Product Upgrade Bulletin 190528REV

SUBJECT:
Inspection/
Installation of
Secondary
Generator Slide-
Out Latch/Catch

ISSUE DATE:
August 2019

On motorhomes affected by this Product Upgrade, the secondary catch system for the manual slide-out generator tray may have not been installed. If the secondary catch system is not present, please follow the steps outlined in this bulletin to install a service kit as a customer convenience.

Figure 2

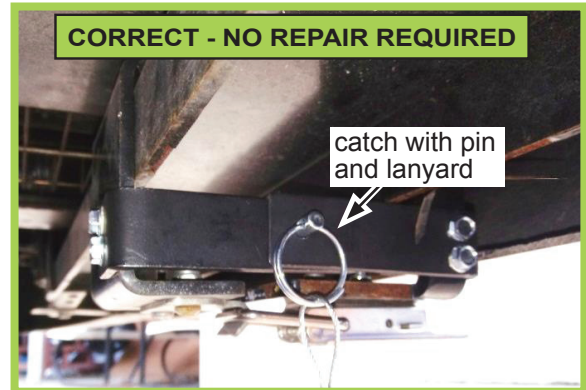
Secondary Latch Catch with Pin and Lanyard **Missing**
Upgrade Repair Kit A Installation Required
Follow Steps 6-13

5. If repairs are required, refer to the following information and photos to obtain the repair kit that applies to the product description and model year of coach on which you are working. Follow Steps 6-13 for Repair Kit A; follow Steps 14-23 for Repair Kit B.

Figure 4

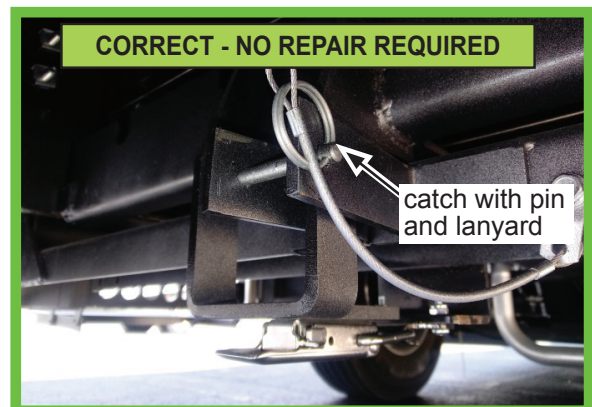
Secondary Latch Catch with Pin and Lanyard **Missing**
Upgrade Repair Kit B Installation Required
Follow Steps 14-23

Figure 6

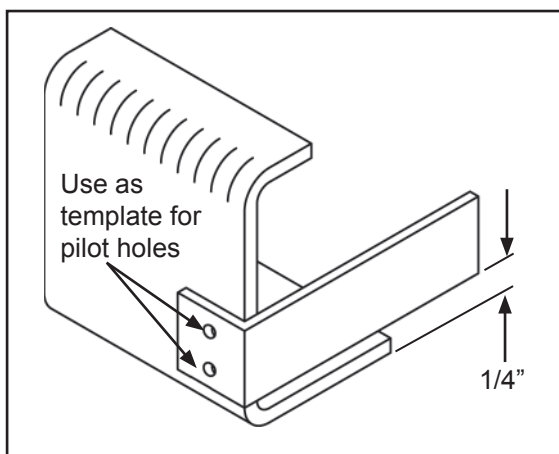
6. Ensure the primary generator latch is engaged and the generator slide-out tray is closed. Place Bracket 1 (from Repair Kit A) 1/4" up from the bottom of the generator slide-out stationary latch/catch mounting pad; use it as a template to mark and drill two 5/32" diameter pilot holes in the rear, vertical surface of the stationary latch/catch mounting pad. Refer to Figures 6 and 7.
7. Using two #10 HWH self-tapping screws, attach Bracket 1 to the fixed generator latch/catch mounting pad using the pilot holes. See Figure 8.

Figure 8

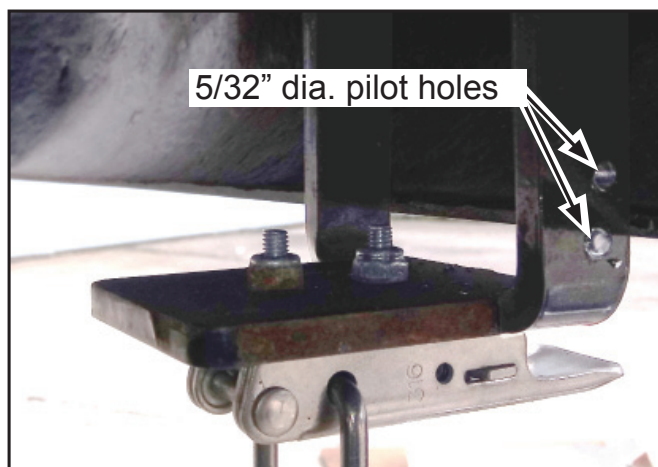
8. While holding Bracket 2 (included in Repair Kit A) aligned with previously installed Bracket 1, mark and drill two 5/32" diameter pilot holes in the side, vertical surface of the movable generator latch mounting pad as shown in Figure 8.

Figure 9

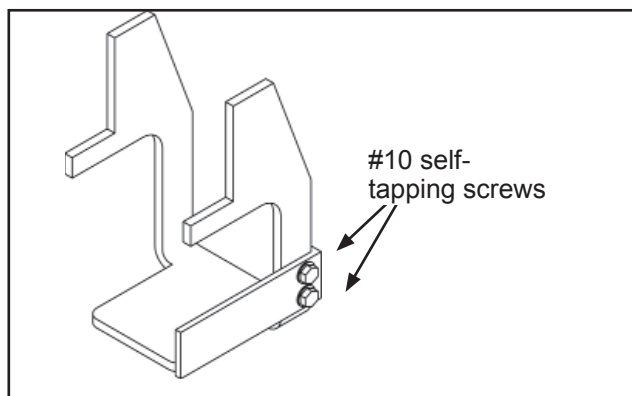
9. Using two #10 HWH self-tapping screws (included in Repair Kit A), attach Bracket 2 to the movable generator latch mounting pad using the pilot holes drilled in the previous step. See Figure 9.

Figure 10

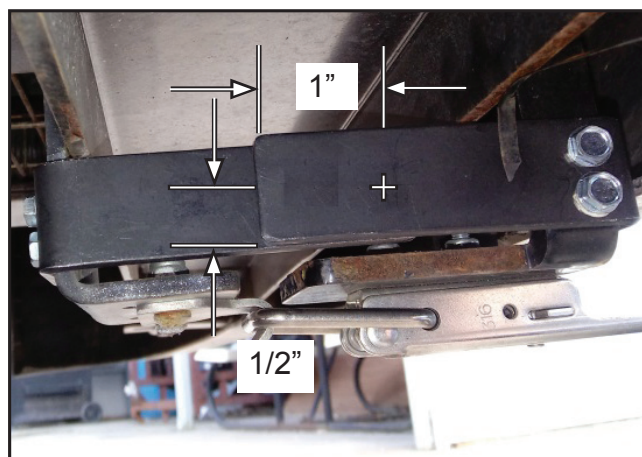
10. On the overlapping bracket, measure 1" in from the end and 1/2" up from the bottom and drill a 5/32" pilot hole thru both brackets; see Figure 10. Using the pilot hole, now drill thru both brackets with a 17/64" drill bit.

Figure 11

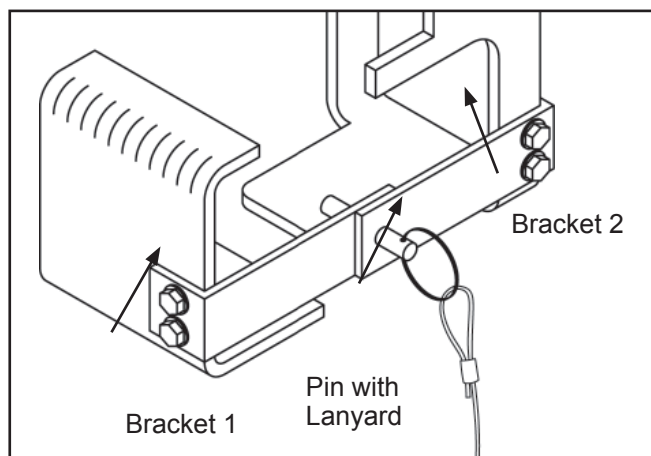
11. Referring to Figures 11 and 12, insert the pin with attached lanyard (included in Repair Kit A) through the pair of aligned holes (created in the previous step) in Brackets 1 and 2. Extend the lanyard towards the doorside of the coach and attach its eyelet to the underside of the generator support frame with a #10 self-tapping screw. Ensure there is minimal slack in the lanyard.

Figure 13

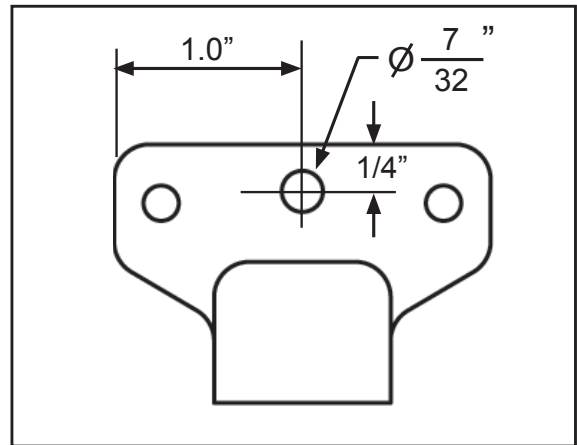
12. After verifying that the primary latch is properly adjusted to allow minimal movement and the secondary catch is in place, drill a 7/32" hole through the latch/catch mounting pad at the location illustrated in Figure 13.

Figure 15

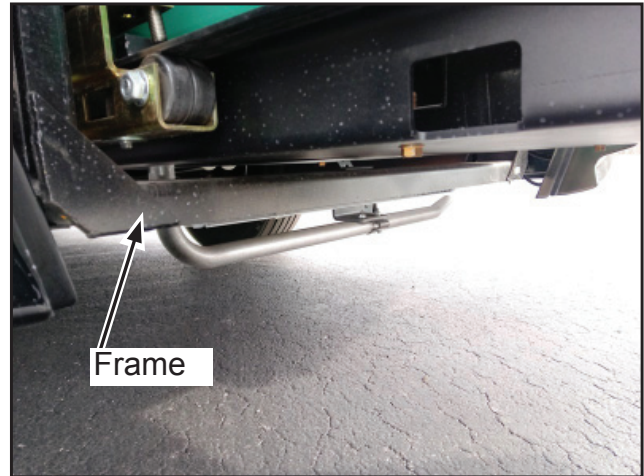
14. Release the primary generator slide-out tray latch and fully extend the generator to allow access to the stationary generator latch/catch mounting pad frame. See Figure 15.
15. Measuring from the doorside of the frame, use the brackets, included in Repair Kit B, as a template to mark the locations for the bracket mounting holes. See Figure 16 for the required measurements.
16. Drill four 5/32" diameter pilot holes through the frame at the marks made in the previous step.

Figure 17

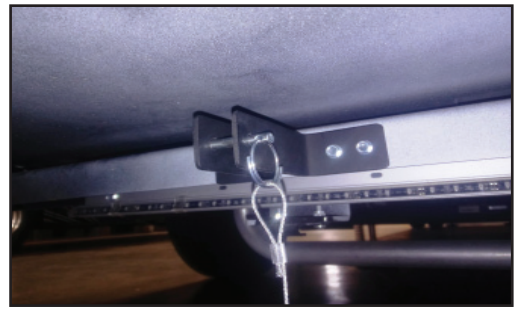
17. Using the holes drilled in the previous step, attach both brackets to the frame with four #10 HWH self-tapping screws. The brackets should be installed according to the orientation shown in Figure 17.

18. Insert the pin, included in the repair kit, to verify it fits correctly. See Figure 17.
NOTE: It may be necessary to tap the brackets into alignment with a hammer.

Figure 18

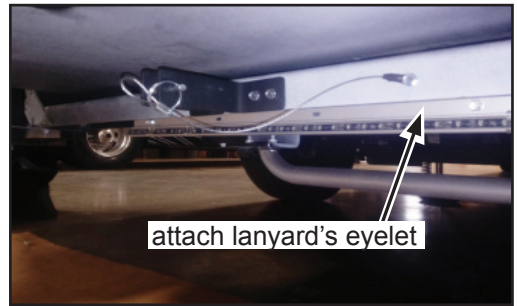
20. Once the fit is verified, remove the pin and reopen the generator slide-out tray. Referring to the orientation shown in Figure 18, pre-drill a 5/32" diameter pilot hole and mount the lanyard's eyelet using a #10 self-tapping screw. Ensure there is minimal slack in the lanyard.

Figure 19

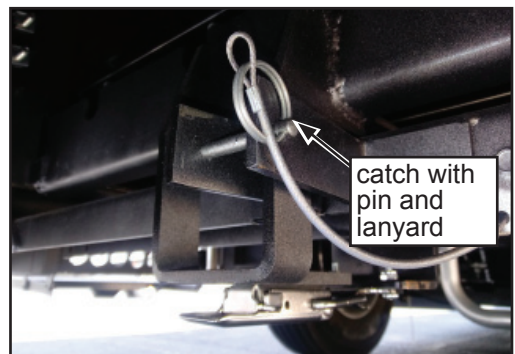
21. Close the generator slide-out tray and engage the primary generator latch. Insert the pin into the newly installed brackets. See Figure 19.
22. After verifying that the primary latch is properly adjusted to allow minimal movement and the secondary catch is in place, drill a 7/32" hole through the latch/catch mounting pad at the location illustrated in Figure 20.
